08/04/2016 Staff feedback on RAI 208-8245; Q 03.08.03-1

In RAI 8245, Question 03.08.03-1 (parts (a) and (b)), the staff requested the applicant to describe a) how the pressure transient for a single sparger activation was developed; and b) what cases of activation (of the spargers) may occur. The staff reviewed the structural aspect of the response to part (a) and found it to be acceptable. However, NRC also needs to review the other aspect of the response that describes the methodology for computing the PORSV spargers pressure transient for acceptance.

Figure 1. The Scaling Factor with Different Initial Pool Temperature

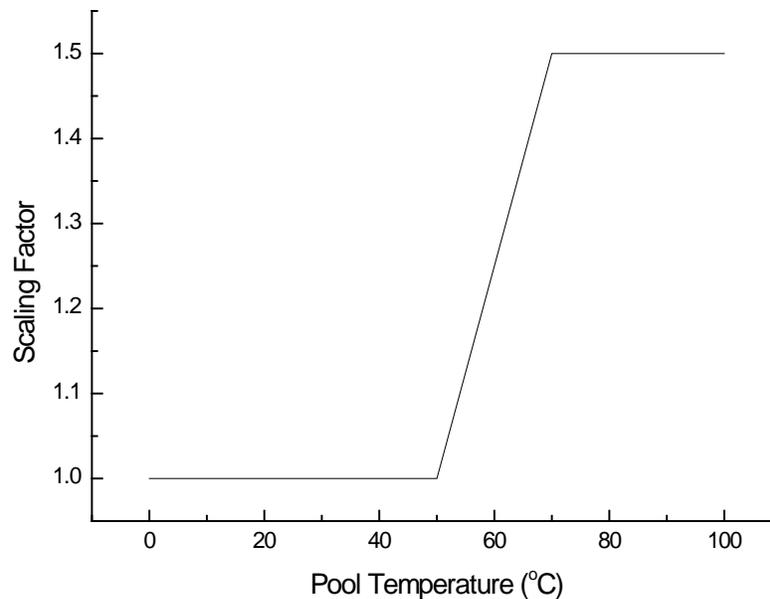
After reviewing the response to RAI 208-8245, Question 03.08.03-1, the staff have identified a need to review the below. We have some preliminary info we would like to see. Please see if you can put the below 2 items in the ERR:

- 1) background for the scaling factors for part (a) (see below), specifically, n-sub-g, n-sub-z, and n-sub-v.
- 2) We also need to confirm that the equation on page 5/9 refers to $r > 2r_0$ rather than just "0" (We have the background info that corroborates this, so this should just be a simple confirmation of a typo).

The Studsvik tests have indicated that the maximum pressure amplitudes are increasing noticeably with increasing pool water temperature above a level of about 50-60 °C. The scaling factor to account for differences in initial pool water temperatures is shown in the Figure 1. The maximum initial IRWST temperature is 120 °F (48.9 °C). Therefore, the scaling factor to account for differences in the pool water temperature, η_T is 1.0.
